Planning Commission Hearing Date: May 5, 2026
Board of Commissioners Hearing Date: May 28, 2026

STAFF ANALYSIS

CASE NO.:	Z-26-1247887	File ID #: 2026-0449
Address:	705 & 711 Hillmont Avenue, Decatur, Georgia	Commission District: 04 Super District: 06
Parcel ID(s):	15-248-07-017 & 15-248-07-020	
Request:	Rezone properties from the C-1 (Local Commercial) Zoning District and to the R-60 (Residential Small Lot -60) Zoning District to construct a new single-family residence.	
Property Owner(s):	William McGrier	
Applicant/Agent:	Ray Bachan / My Next Home Pro, LLC	
Acreage:	0.15 acre	
Existing Land Use:	Single-Family Home	
Surrounding Properties:	North: Commercial (within City of Avondale Estates) South: R-75 East: R-75 West: R-75	
Adjacent Zoning:	R-75 (Residential Small Lot-75)	
Comprehensive Plan:	Commercial Revitalization Corridor (CRC) Consistent <u>X</u> Inconsistent

STAFF RECOMMENDATION: APPROVAL WITH CONDITIONS.

SITE PLAN

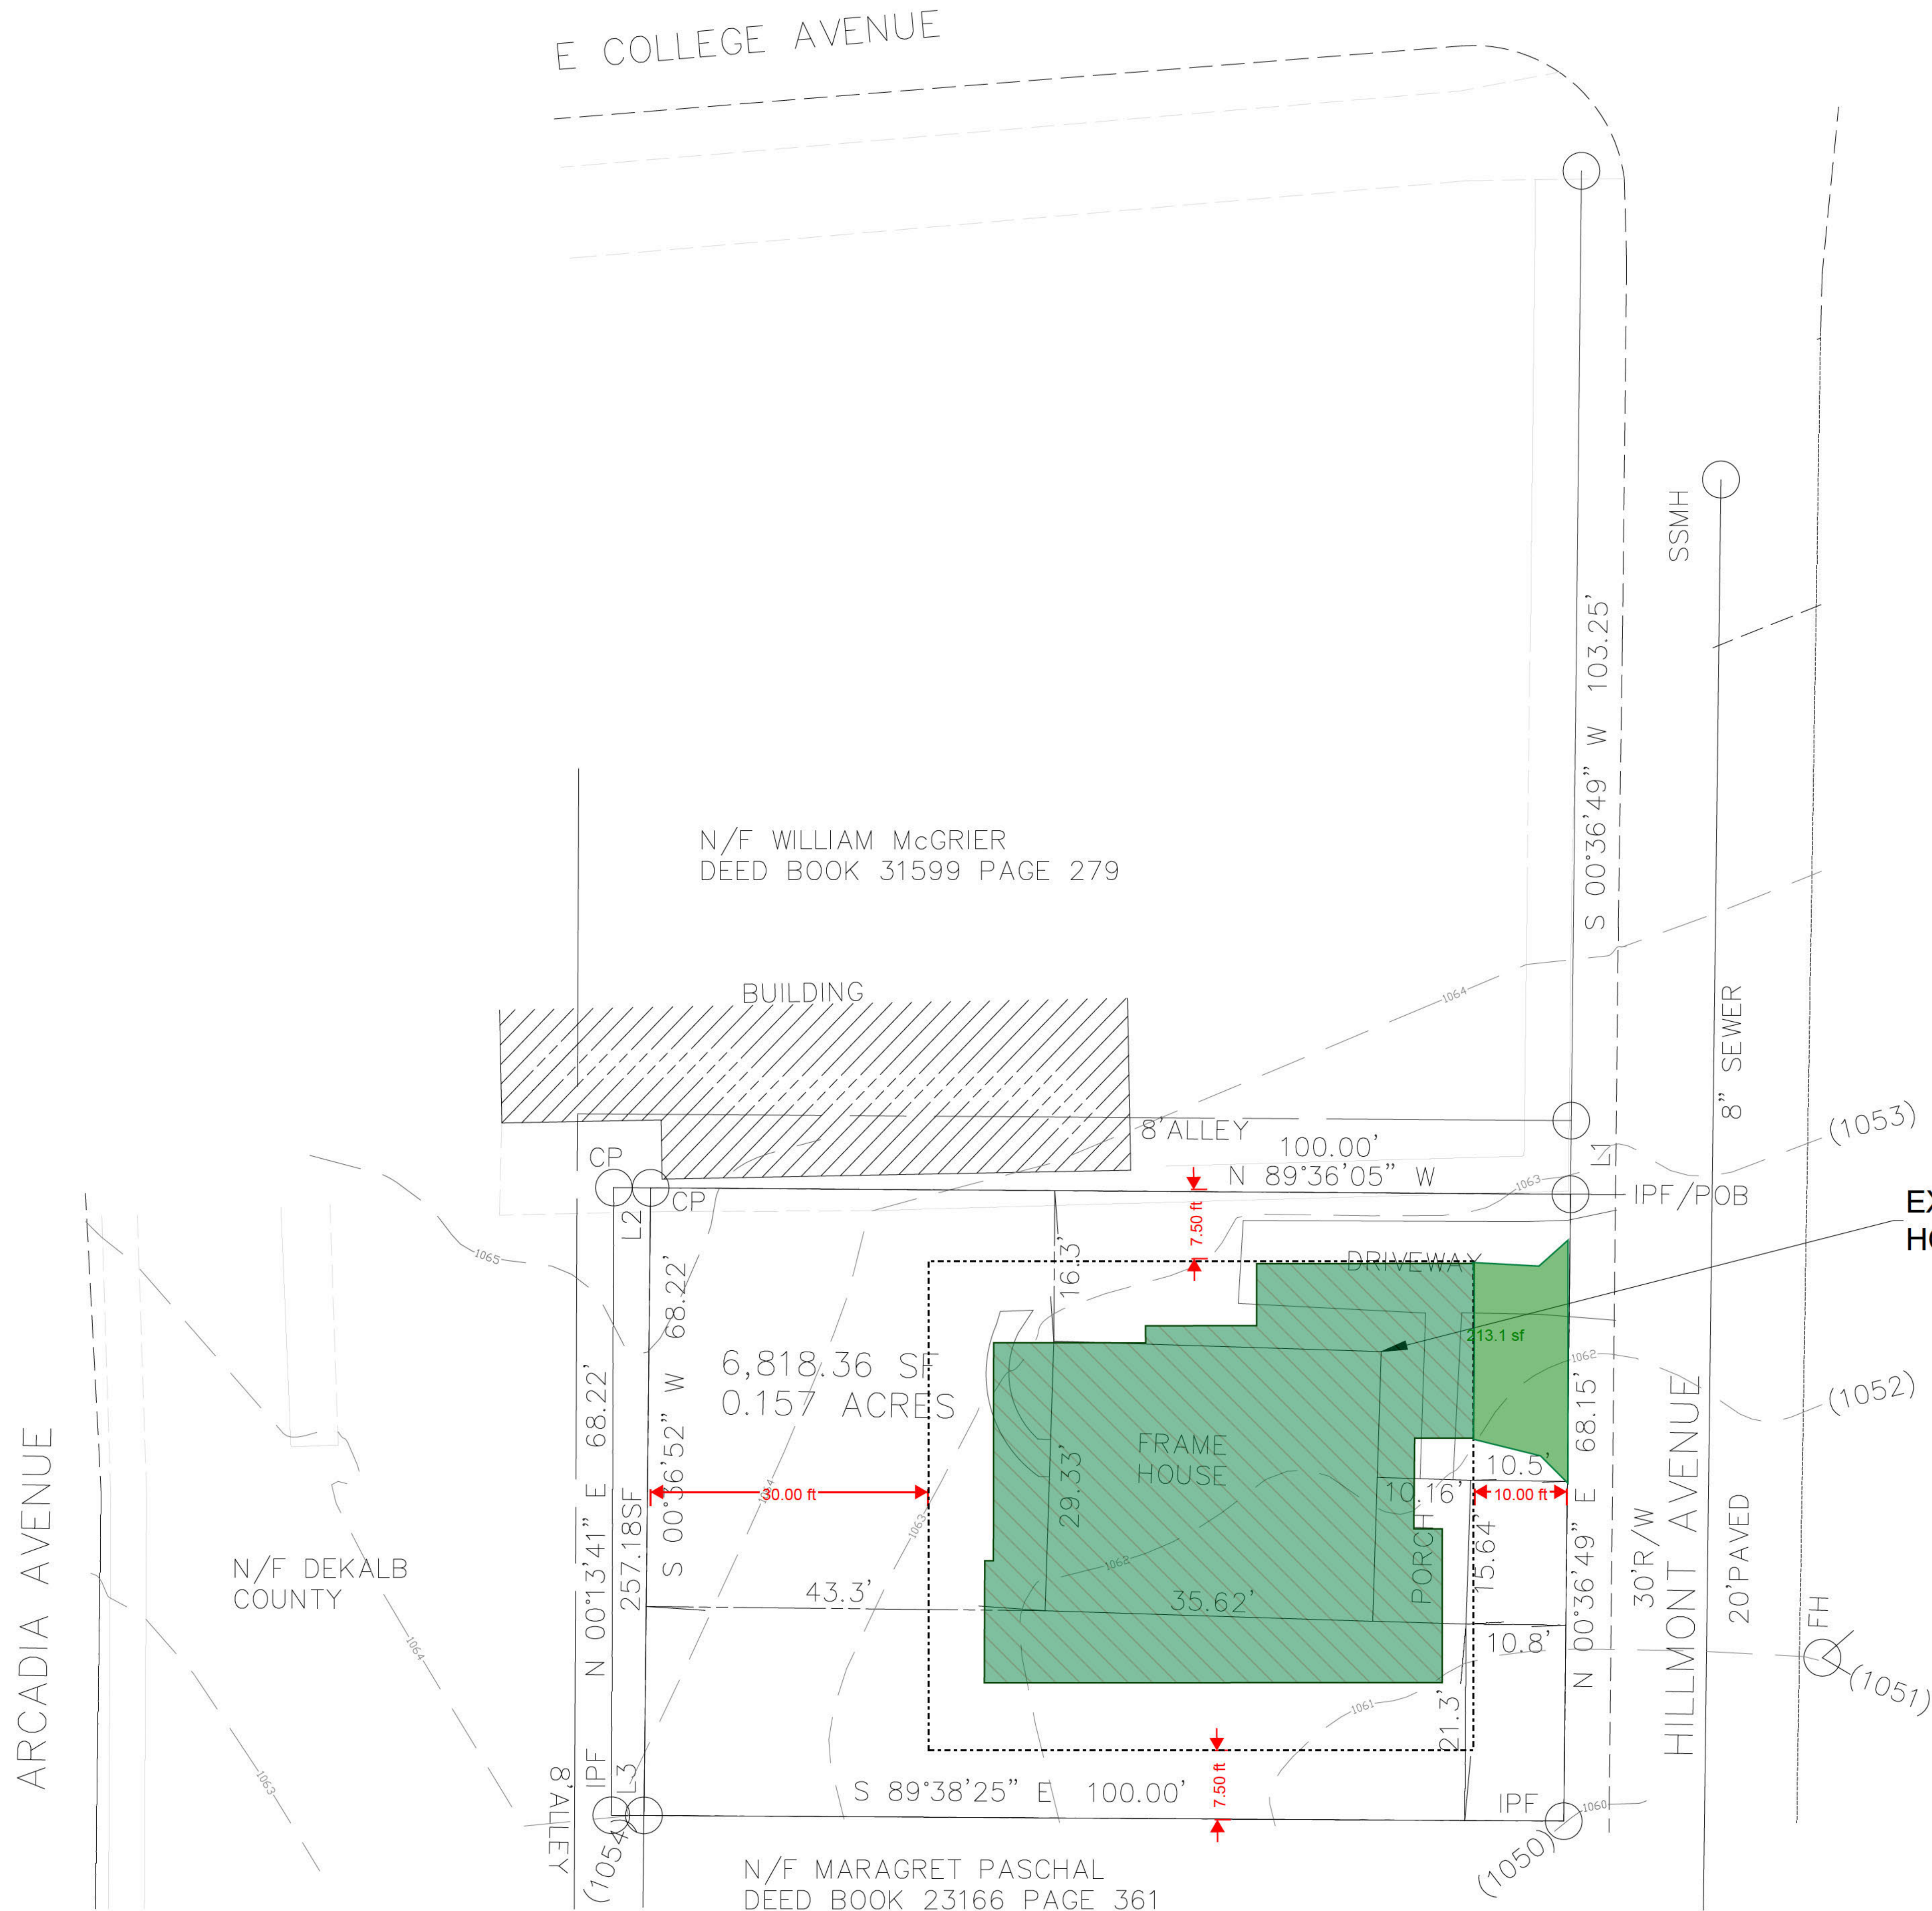
The other properties in the neighborhood is R-75

For new single-family home water quality will be required
